<b>T.I. no.:</b> 2021-25 <b>Updated:</b> -	<b>Topic:</b> SCS / SOUL Software V4.30.9
---	---

## INFORMATION ON SOFTWARE UPDATE

The new software update V4.30.9 eliminates bugs, optimises the platform software and replaces the software version V4.26.7.

### Brand logo replaceable in GUI (Media Package)

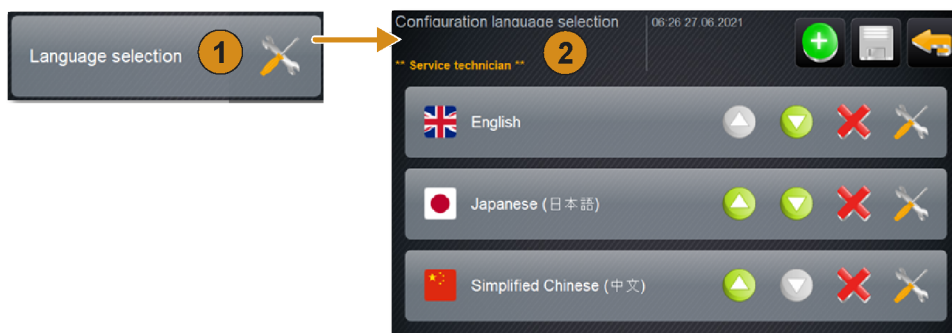
On the Frequent user or Guest mode of the SOUL the Schaerer logo is visible – per default – on the bottom-right corner. On Staff mode no logo can be displayed (the space is reserved).

Starting Software version 4.28 Schaerer’s brand logo may be replaced by another one (in this example, a Schaerer logo in black).

## Language selection configuration

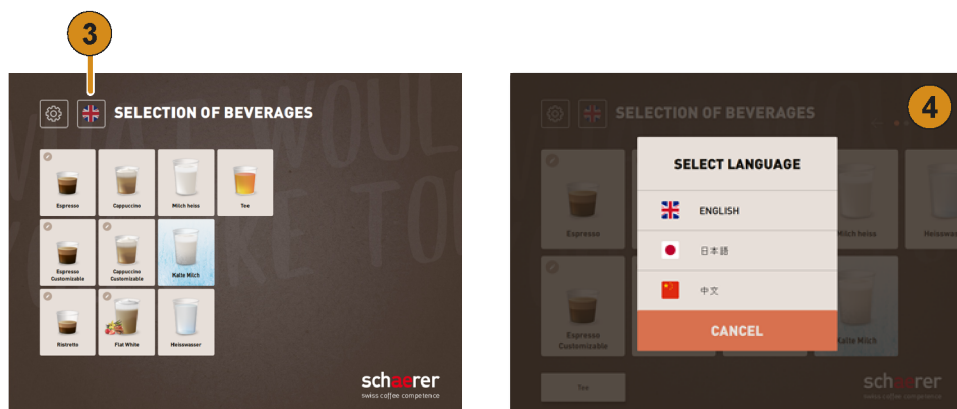
Enables max. 3 additional languageselections directly by the user on the user beverage selection screen. The languages can be freely defined and prioritised. By default, a standard flag is attached to each language but can be changed.

After beverage dispensing the machine reverts to the default language.

With the SOUL, the language for the Management UI can be configured separately from the Guest UI.

The language selection button in the Guest UI is only displayed if more than one language has been configured.
